**Report of the 2011 Independent Review Panel (IRP) on the
Implementation of Reasonable and Prudent Alternative (RPA)
Actions Affecting the Operations Criteria And Plan (OCAP) for
State/Federal Water Operations**

Prepared for: **Delta Science Program**

9 December 2011

Figure 1. Schematic for modeling routing of fish and water through the Delta.

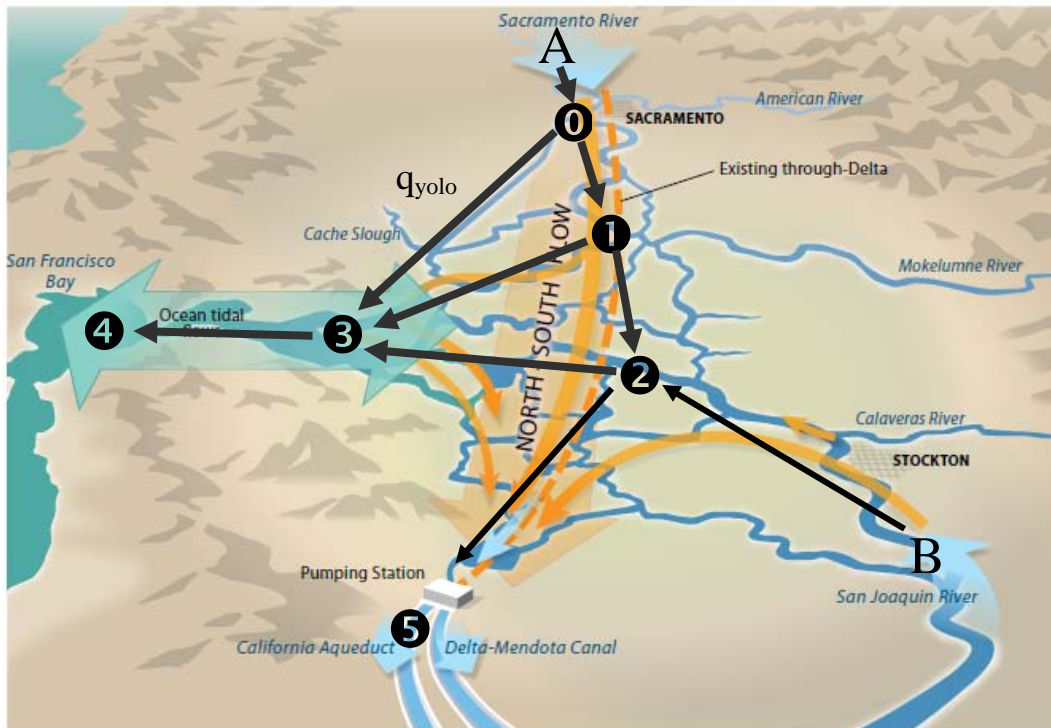
Framework for Managing Delta Actions in Real-Time. The passage of fish through the Delta is complex and involves multiple passage routes and fish entering the system from different rivers. The common measure of Delta operations is survival of fish from the Sacramento or San Joaquin rivers to the San Francisco Bay. Consider in this example survival from where the Sacramento River enters the Delta to San Francisco Bay. Designate survival over the entire complex network as S_{04} (Figure 1). Note that fish have many routes from the River to the Bay and for simplicity we identify four primary routes: 1) Route 03 connects the Sacramento River to San Francisco Bay through Yolo Bypass, 2) Route 013 goes through the main stem of the Sacramento River, 3) Route 0123 goes into the Delta and out through the San Joaquin River and 4) Route 0125 goes into the Delta and out to the Bay via salvage and transportation at the pumps. The total survival through the system depends on the fraction of fish taking each route and the survival through each segment as

The panel believes that process modeling will likely play a major role in the assessment of RPA effects. A process approach describes the routing of fish through the Delta (e.g. Figure 1) and expresses the effects of changes in flows on fish movement and survival. The Delta flow models are a starting point for developing process modeling. The movement and behavior of fish can be approached through differing degrees of complexity from making assumptions that fish routing is in proportion to flow routing or that fish routing involves small scale flow characteristics such as is modeled with the ELAM approach (Goodwin et al. 2006). The panel recommends taking both simplified and detail approach in developing process models as described in Rose et al. (2011)

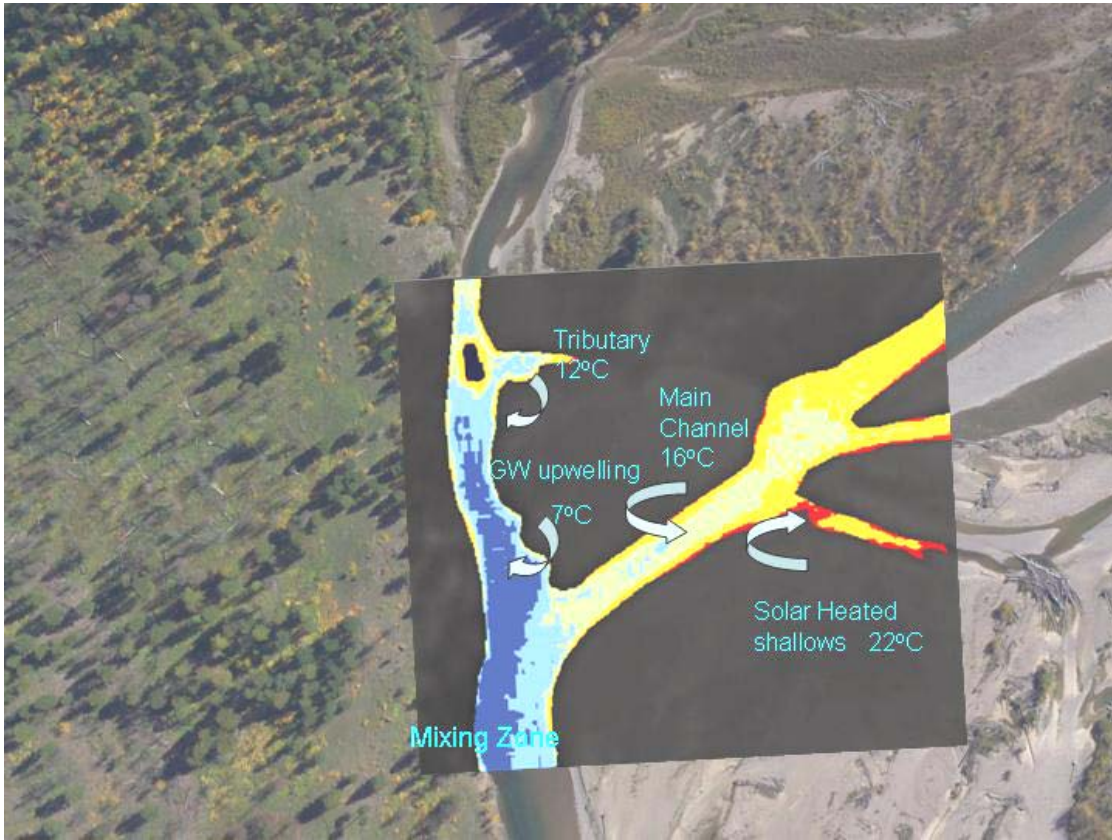
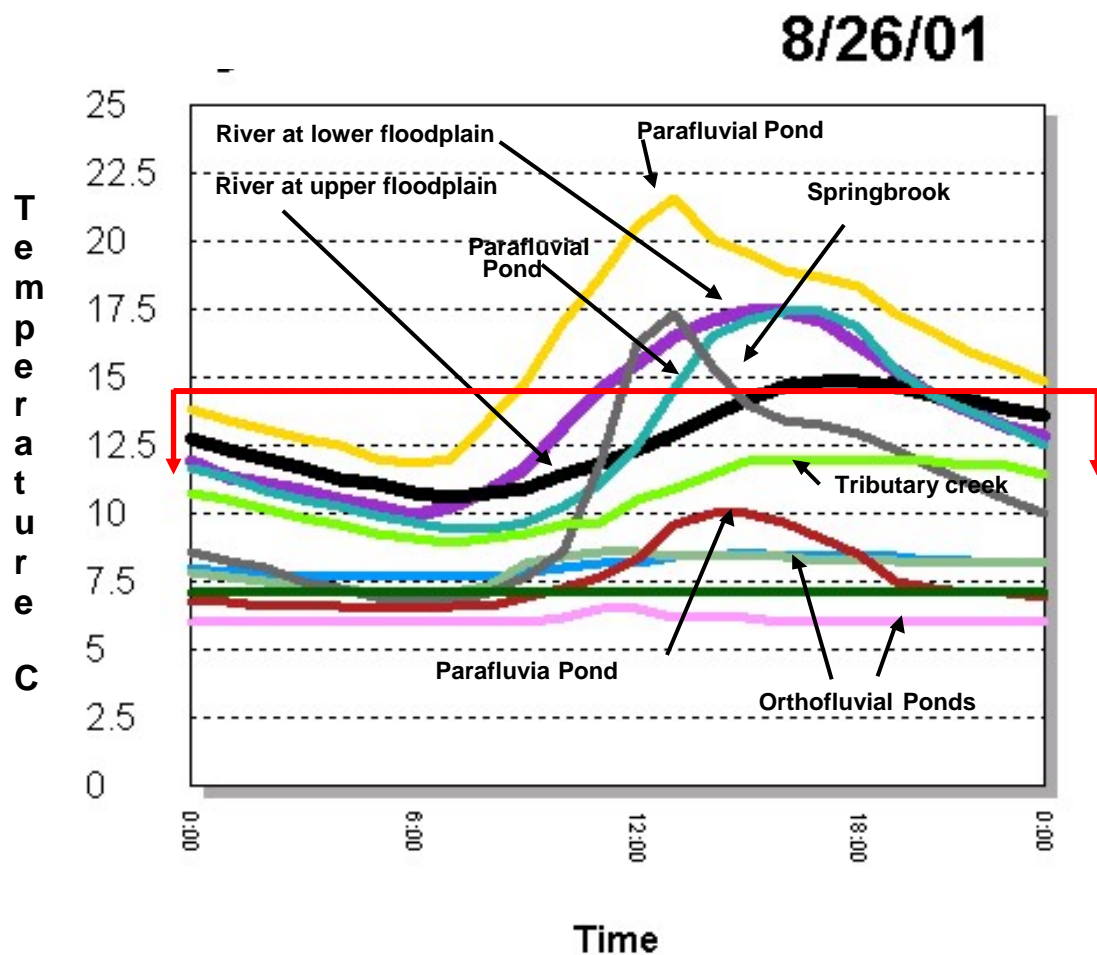
Given the expected spatial variability in riverine temperatures (e.g., Figs. 5 and 6), monitoring flow releases from dams using only a few temperature gauges, may not be sufficient to predict thermal impacts on species of concern. Moving to upstream gauging stations only allows RPA's to meet some main channel flow temperature target at a single point. This does not provide sufficient information to assess whether or not an RPA meets the goals of improving survival during the early life stages of listed species. Several approaches could be considered to improve the spatial resolution of thermal data with the aim of better matching it to spatial variation in the biological data (e.g., distribution of redds). For example, deployment of more inexpensive temperature loggers within key reaches of some systems (e.g., Clear Creek and Stanislaus River) could provide a cost effective means of gathering the data necessary for retrospect analysis of both models and RPA actions. Alternatively, airborne collection of remote sensing imagery has become relatively inexpensive. Where possible, the location of fish occurrence, adults, juveniles, redds, etc. can be overlain on maps (e.g. Figs. 4 & 5) to provide better spatially explicit links between variation in physical variables and fish responses, as well as predicting the effects of water operations (e.g. rapid changes in flows from
